RE: City of Duluth Bid #11-4403
(New Passenger Terminal Bid Package 2B)

Addendum No. 2

**NEW PASSENGER TERMINAL
DULUTH INTERNATIONAL AIRPORT
DULUTH, MN**

A212

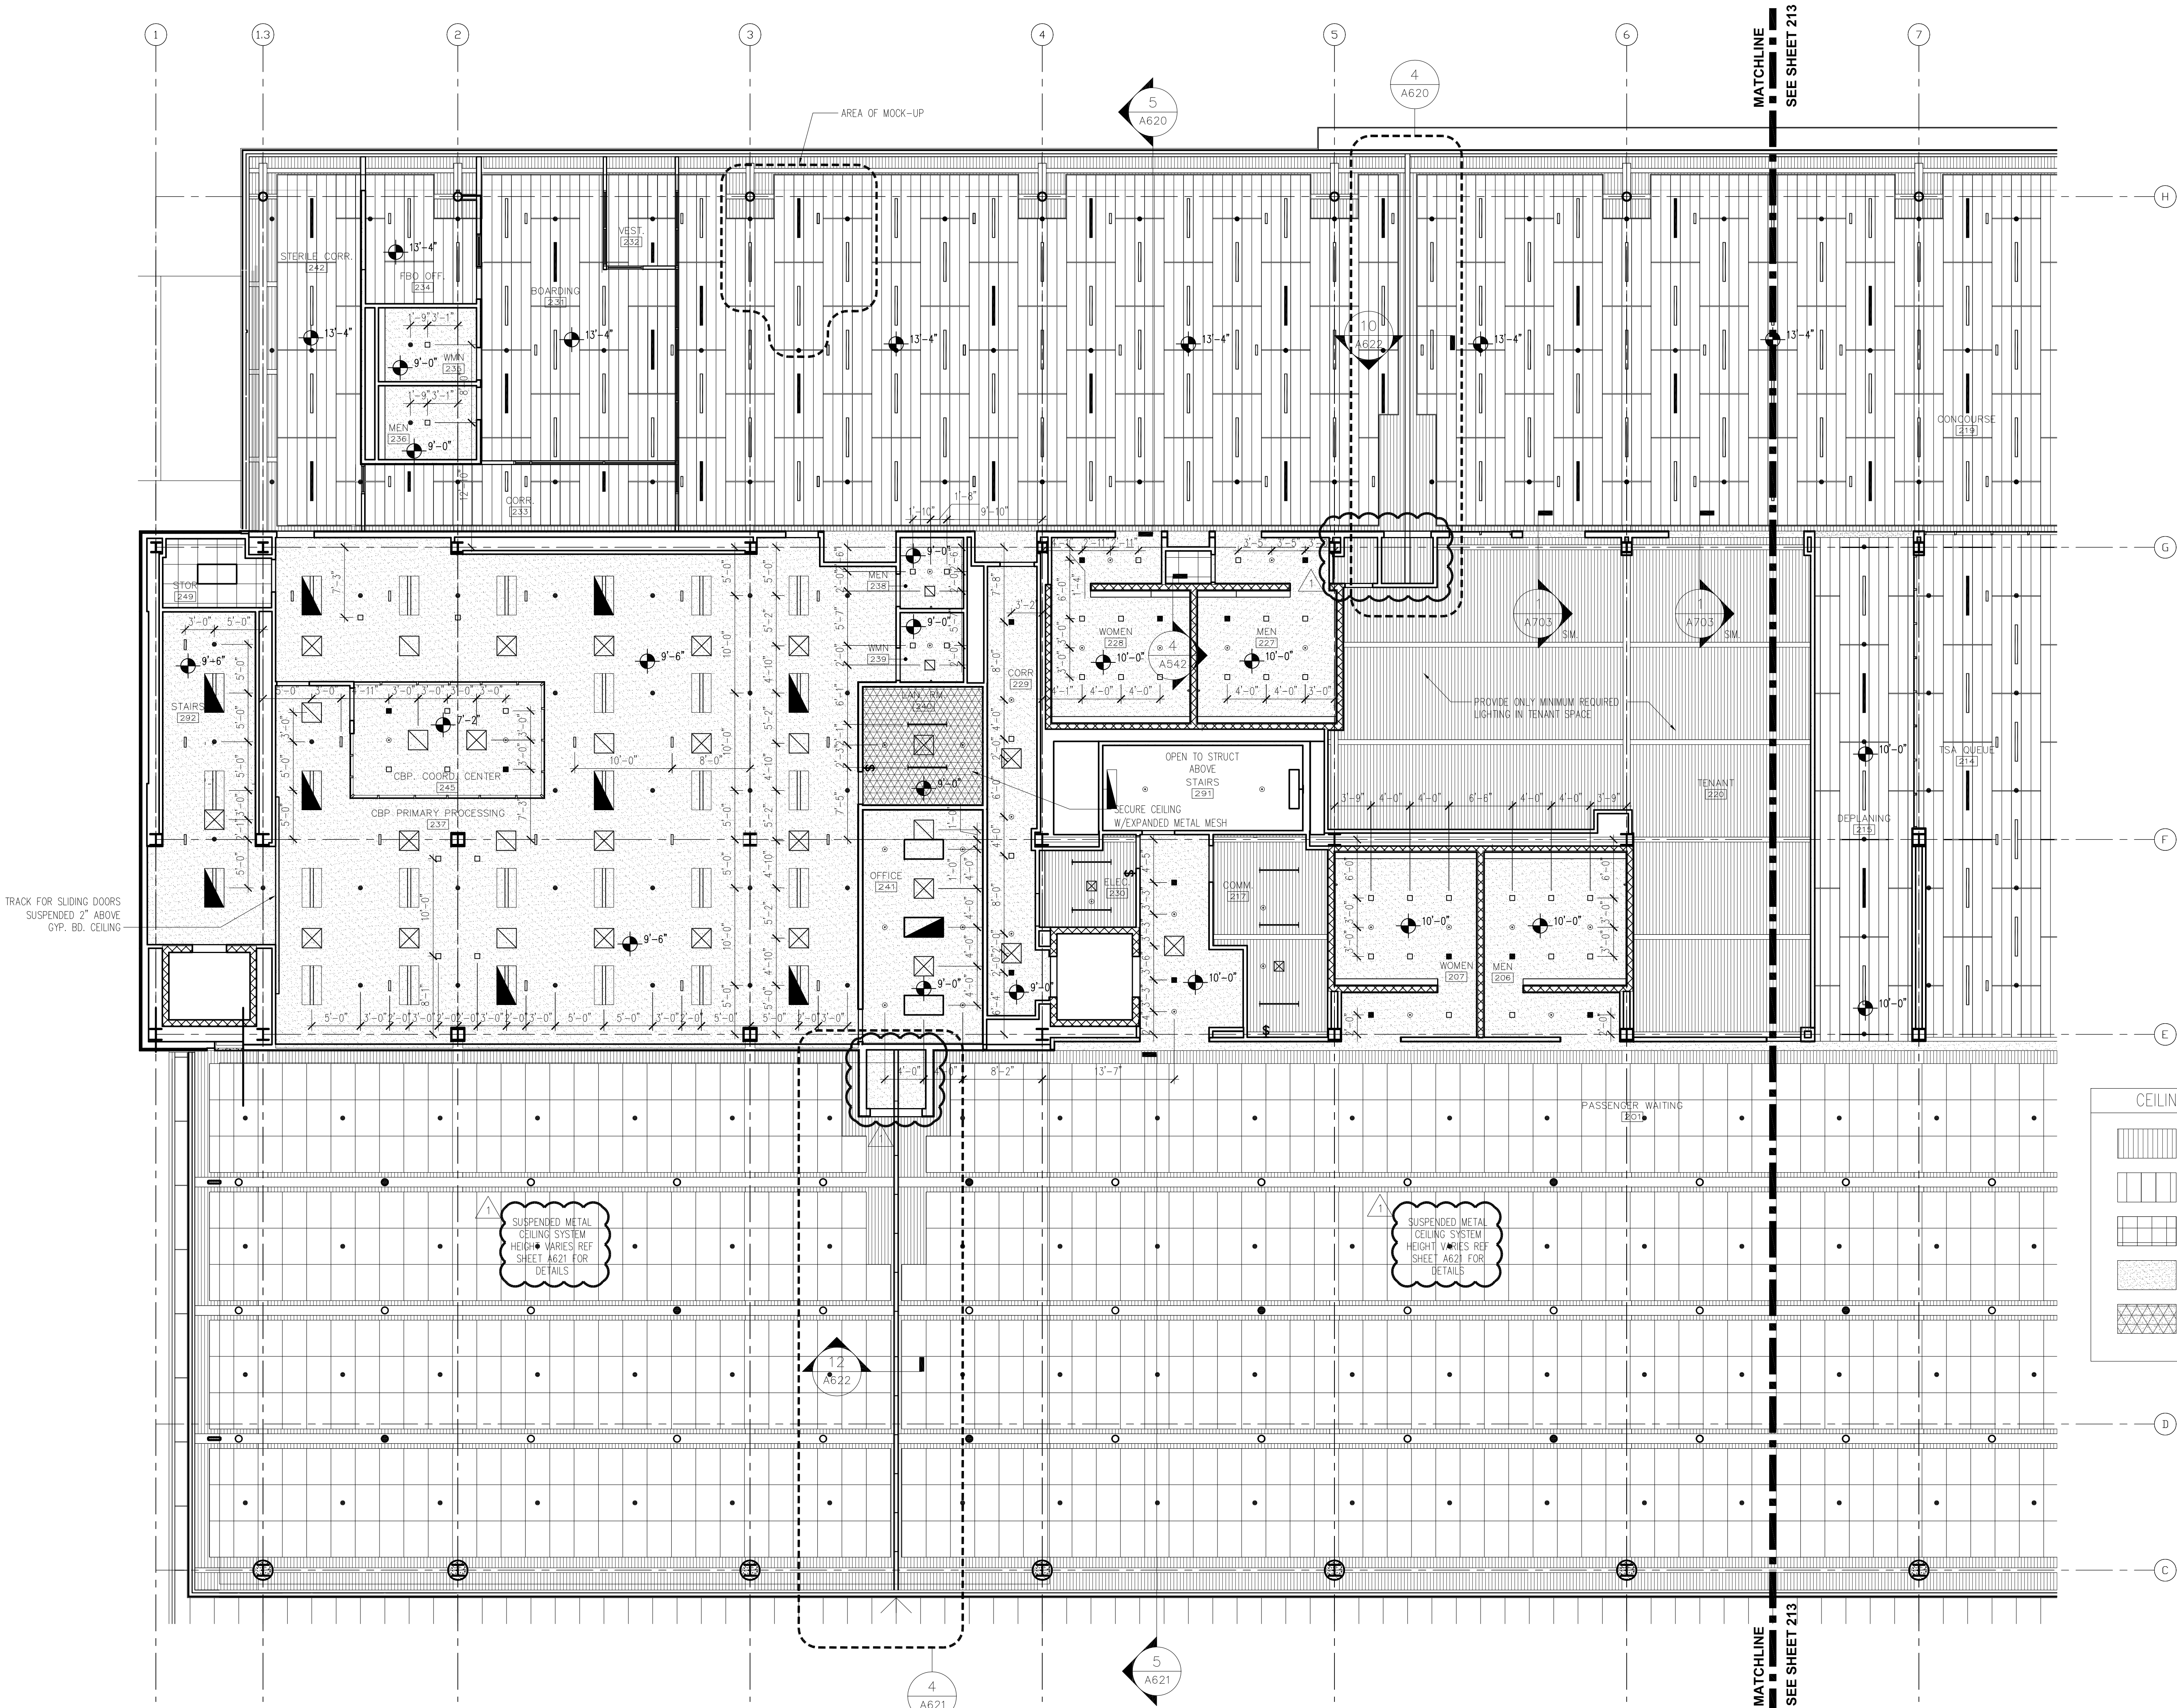
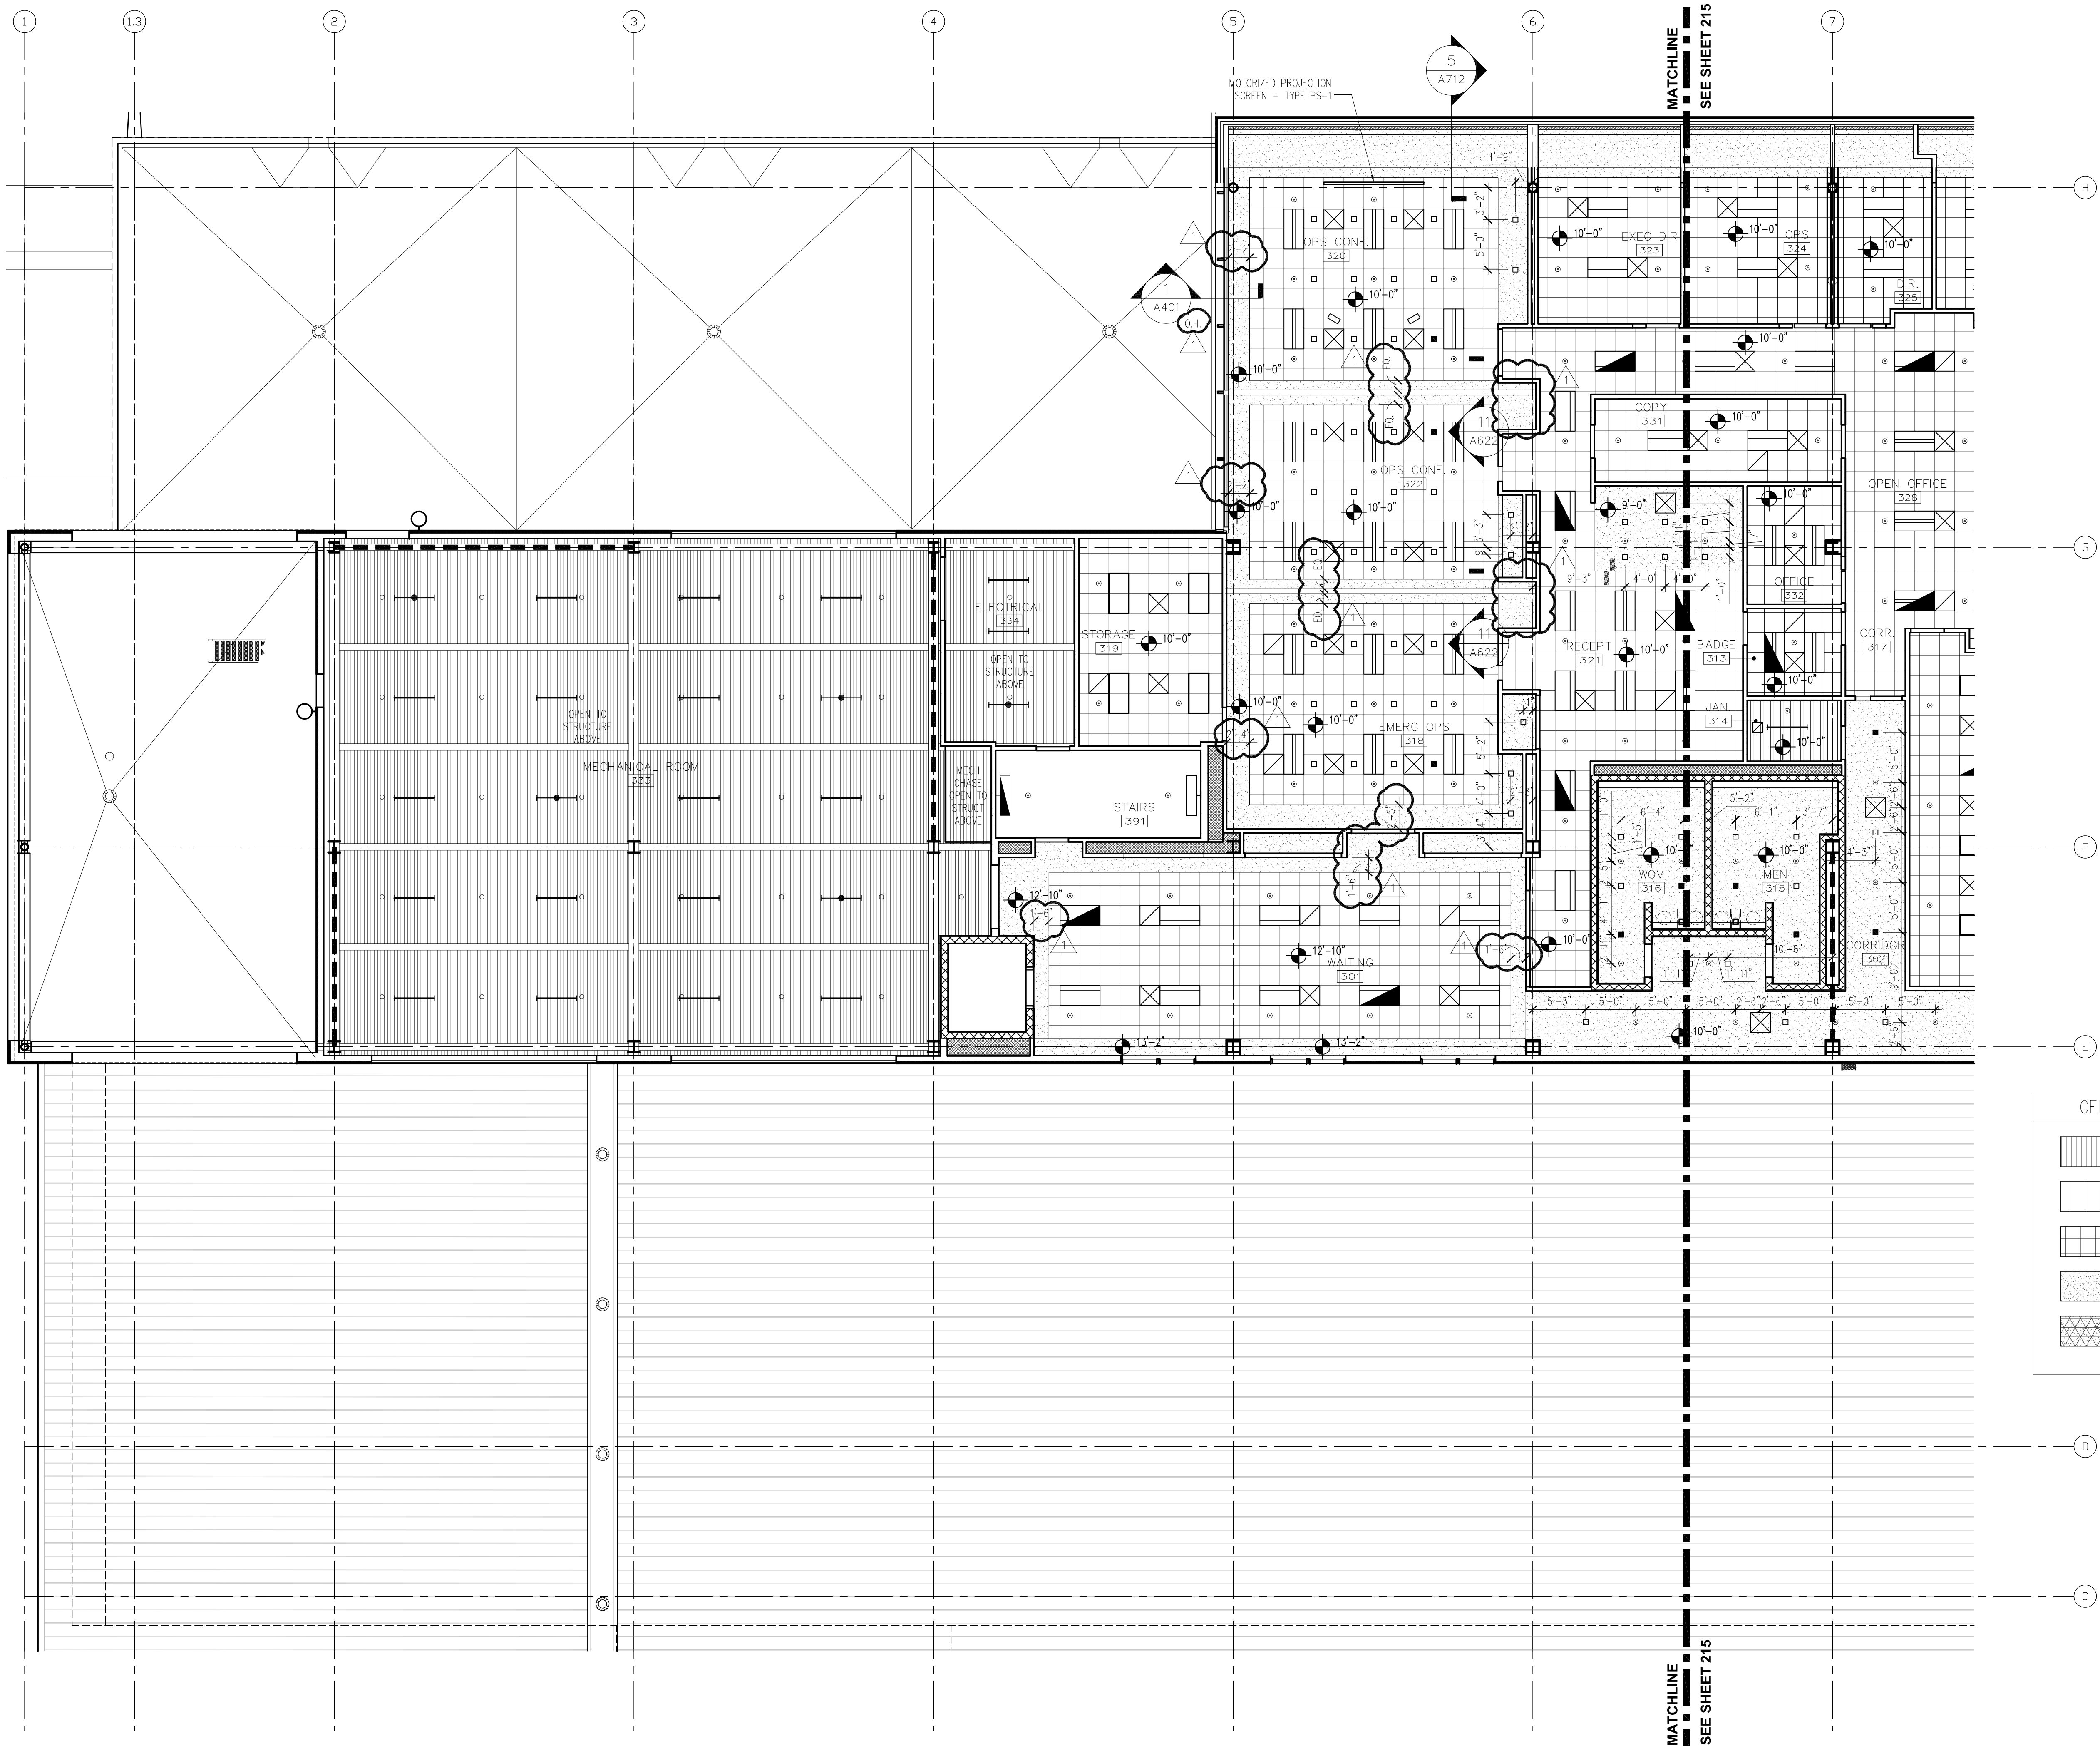
- Sheet A212: Clarified ceilings in closets. Corrected typographical errors.
- Sheet A214: Added dimensions for gypsum board ceilings. Added ceilings in movable partition pockets.
